**From:** Ethan Ahlberg  
Noll & Tam Architects

**Re: 08ESMF00-2012-TA-0387-1  
Corps File No. 2012-00032S - Oakland Zoo California Trail  
Further details and clarifications – Section 7 Consultation  
Response to Fish and Wildlife Service Letter Received May 1<sup>st</sup>, 2012**

**Re: Oakland Zoo California Trail  
Fire Fuel Management Plan Framework**

**OVERALL SITE EXHIBIT**  
**CALIFORNIA TRAILS EXHIBIT**  
**KNOWLAND PARK-OAKLAND ZOO**

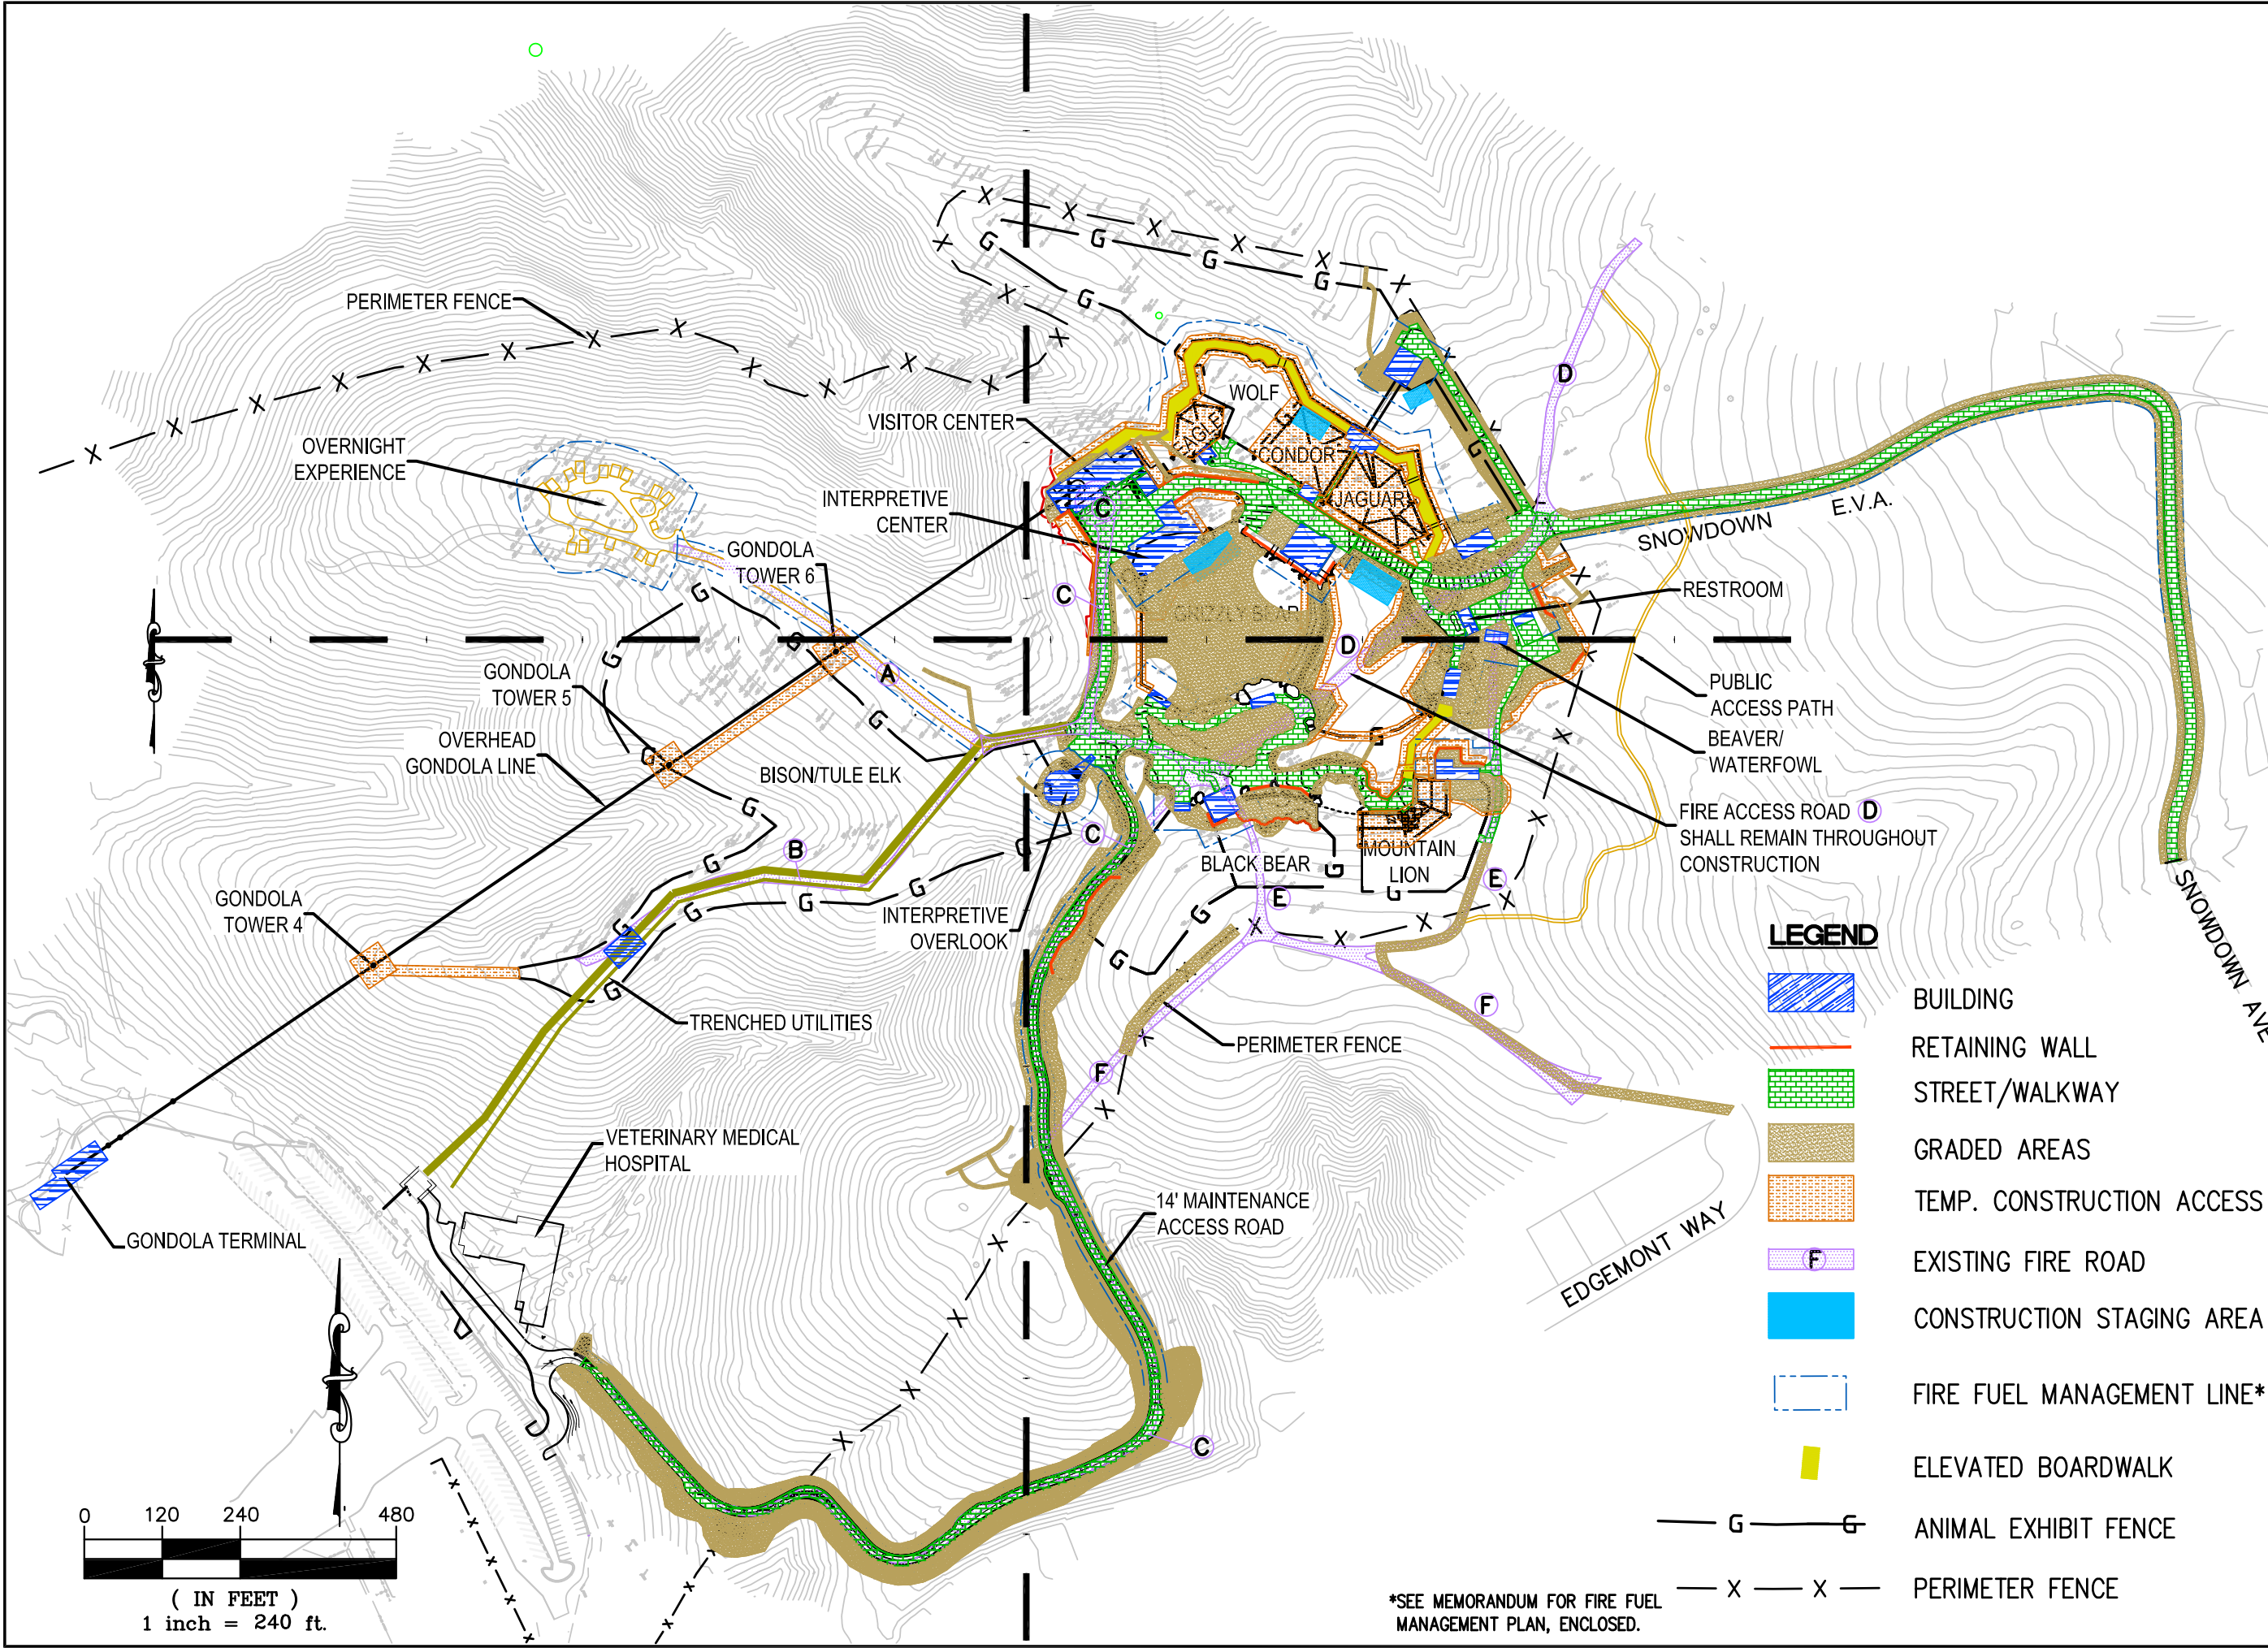
- 5) "Page 8, Section 2.2.1 Detailed Description of the Project, Aerial Gondola People-Moving System: This subsection does not describe the construction methods including support structure construction, equipment, construction timing or duration, or access roads needed to construct the gondola."

- 6) "Page 8, Section 2.2.1 Detailed Description of the Project, California Interpretive Center: This subsection does not describe the construction methods, construction footprint, equipment, construction timing or duration, or access roads needed to construct the building."

Refer to **Figure 1 and 4** for the overall location of each tower, existing fire roads, temporary access ways, and construction zones. Each gondola tower (7 total) will require a 12ft x12ft spread footing onto which a steel tower will be installed. The lower station and towers 1, 2, and 3 are located within the existing zoo footprint and will not affect any natural habitat.

The Visitor Center and Interpretive Center buildings are located at the end of the **Existing Fire Road C**, please refer to **Figure 1 and 2**. Construction access will be provided with the construction of the **permanent fire access lane**, which will be located following approximately the same position as **Existing Fire Road C**. The permanent fire access lane then extends through to the east and connects to **Existing Fire Road D**, providing a loop access for

*The perimeter fence will be eight feet tall, built with 3 inch diameter steel posts set into concrete piles at 10 feet on center. A steel bottom, middle, and top rail will hold a chain link mesh. The fence will be constructed in a linear fashion by hand, no vehicles will access these locations. Fence inspection will be done from the interior of the exhibits and by hand. Please refer to **Figure 1**.*

**Please refer to Figure 1 for existing roads and new roads and pathways.**

*The new permanent fire lane which follows the **Existing Fire Road C** will be paved in asphalt. The fire access lane will be built in a linear fashion with very little additional construction access width required. Re-grading zones between 3 and 60 feet outside the road boundary each side will occur from the existing Veterinary Hospital up to the junction with **Existing Fire Road A**. From this point running north to the Interpretive Center and Visitor Center the new permanent road will slightly bend to the east further than the Existing Fire Road C to allow more clearance from the chaparral habitat. Where the lane is higher than existing grade, piles will be driven as a foundation and structural framework, with wood lagging installed on the back side. This will then be backfilled from the road side to stay away from any sensitive vegetation outside the road, refer to **Figure 1** for overall layout, **Figure 2a and 2b** showing elevated road sections, and **Figure 7a** for typical at grade sections. At the Visitor Center and Interpretive Center the lane will form part of a larger plaza area with a concrete paver or stained concrete finish, planting zones and seating areas. From this point the **Existing Fire Road C ends**, and the new permanent fire lane will run east to connect with **Existing Fire Road D**. This section will be paved in asphalt, and where above existing grade be formed with the driven piles and lagging method described above to minimize impact to adjacent vegetation and oak trees. Then the new fire lane will follow Existing Fire Lane to the eastern boundary of the project site connecting to the public way at Snowdown Ave., refer to **Figure 1 and 6**.*

***Figures 1, 2, and 3** show limitations of grading which are depicted by hatching, representing 3 forms of grading disturbance in the project: Permanent Disturbance (building foundation footprints, walkways, and roads); Graded Areas (minimal space for permanent operational access around each building, and transition slopes); and Temporary Construction Access (limits for equipment to perform the grading operation that with temporarily disturbance). The legend designates the location of these 3 grading forms which are keyed to the plan on each figure.*

**FIG 2**  
 1 of 1

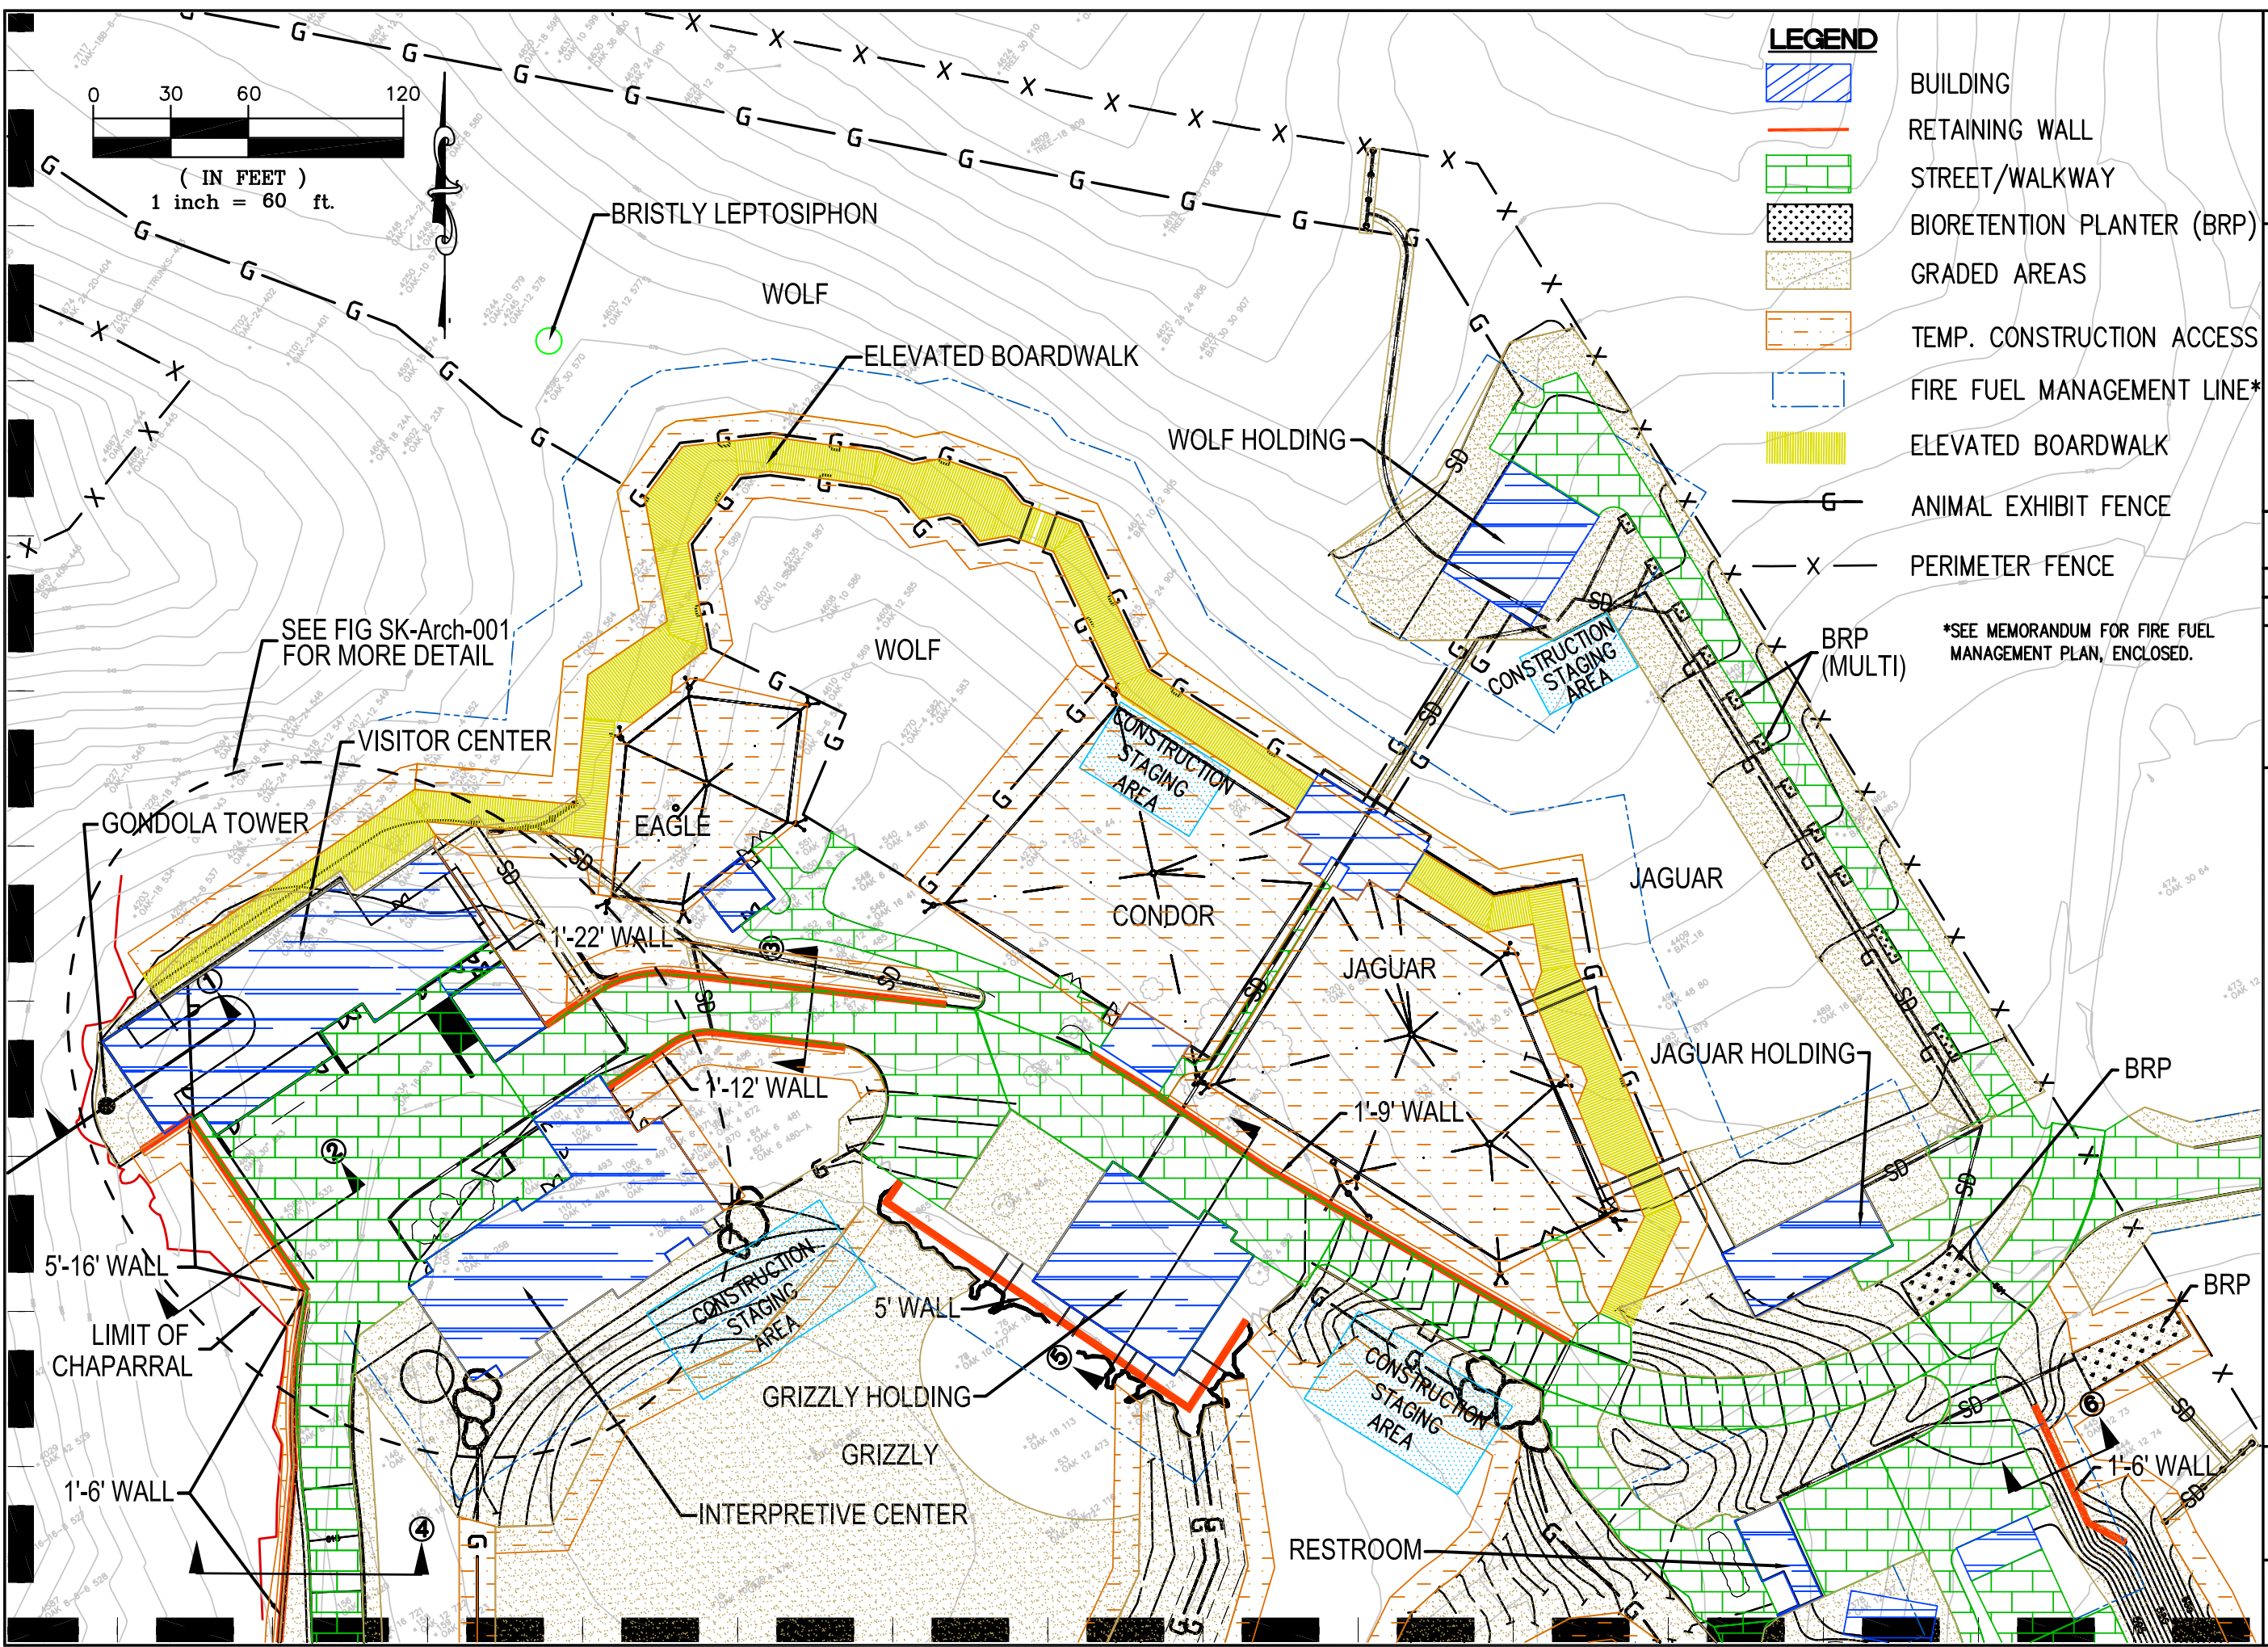
- 7) "Page 8-9, Section 2.2.1 Detailed Description of the Project, Wolf, Jaguar, Eagle and Condor Exhibits: This subsection does not describe the construction methods, construction footprint, equipment, construction timing or duration, or access roads needed to construct the exhibits."

- 9) “Pages 9-10, Section 2.2.1 Detailed Description of the Project, Grizzly Bear Exhibit: This subsection does not describe the construction methods, construction footprint, equipment, construction timing or duration, or access roads needed to construct the exhibit.”

**Refer to Figure 2 and the detailed descriptions below:**

*The exhibit areas will be bisected by an elevated walkway serving as the public viewing path through all exhibits in this section. The elevated walkway will follow the existing contours of the central hill of the site dividing each exhibit into a smaller zone uphill of the walkway and a larger zone downhill from the walkway. Impact in the uphill side of the walkway will be greater due to increased landscaping, irrigation, and aviaries where they occur, refer to the response to Question 15 for in depth landscaping and irrigation information. The larger downhill portions of the exhibit areas will not be modified except for native species enhancement and limited irrigation view long spray sprinkler heads, refer to the response to Questions 23 and 24. With the exception of construction of the wolf holding structure (see below), all construction activities in the area on the downhill, north side of the elevated walkway will generally be done by hand with great care to minimize disturbance to existing habitat. The existing ground cover in this area is largely grassland.. There is a graded area at the exterior fence near the wolf holding building that will require an excavator, refer to **Figure 2**.*

**Refer to Figures 2, 2b, and 3 for this detail description section.**

*This structure is located on the north side of the exhibit, adjacent to the proposed permanent fire lane, refer to **Figure 2**. The structure is a single story, enclosed building and includes with a concrete slab on grade, full height concrete block walls, and a composite steel and concrete green (planted) roof. The building will have a sprinkler system, plumbing, drainage, power, and lighting as well as mechanical ventilation and heating. An exterior back of house animal enclosure area is fenced in on the northwest side of the building. A site retaining wall divides this building from the exhibit, see **Figure 2b**. Construction access, storage, and staging will be from the new permanent fire lane. An excavator will prepare the foundation and graded areas, and the concrete foundations, slab, and grout in the concrete masonry walls can be poured from a concrete vehicle parked on the adjacent permanent fire lane. The roof structure will be craned into position. The crane will be located on the permanent fire lane.*
